# UNITED STATES PATENT AND TRADEMARK OFFICE

10/586,574

<b>Office Action Summary</b>	<b>Application No.</b> 10/586,574	<b>Applicant(s)</b> HARTEL ET AL.	
	<b>Examiner</b> MICHAEL CALABRESE	<b>Art Unit</b> 3637

## **DETAILED ACTION**

Fontana et al.

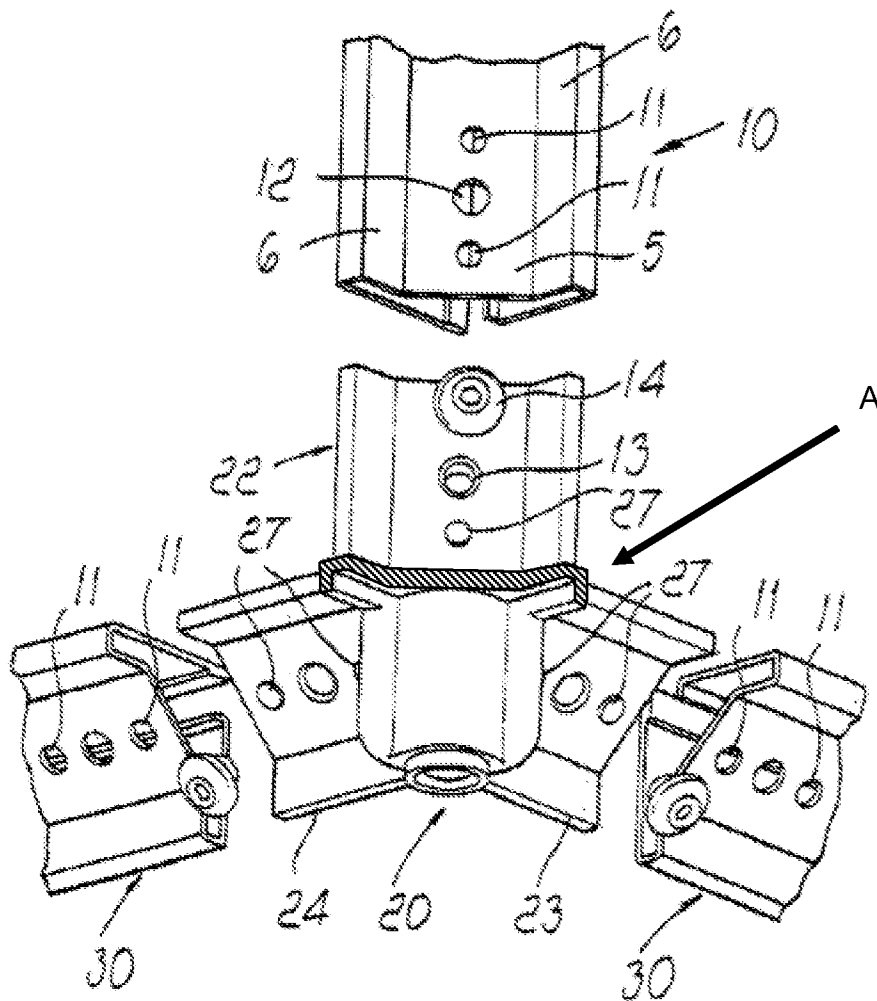
74. Fontana is cited for further teaching the vertical frame legs (10) of the cabinet rack have a profiled element with a plug-in connection (See Figure 2) for a plug-in element (22) of the corner connectors (20), wherein with an exterior contour the profiled element forms the exterior receptacle (See Figure 2; formed in between element 6's) which is symmetrical with respect to a diagonal plane of the bottom frame, and the top frame.

77. Fontana is cited for further teaching the bottom frame and the top frame of the cabinet rack have corner receivers (inner channels of 30's) into which the corner connectors (23, 24) are placed with a filler element (A; See marked up Figure 2 below) and connected with the bottom frame and the top frame, and with an exterior contour the filler elements (A) of the corner connectors (20) extend the exterior receptacles (area between 6's) of the vertical profiled frame element (10) of the cabinet rack beyond the bottom frame and the top frame.
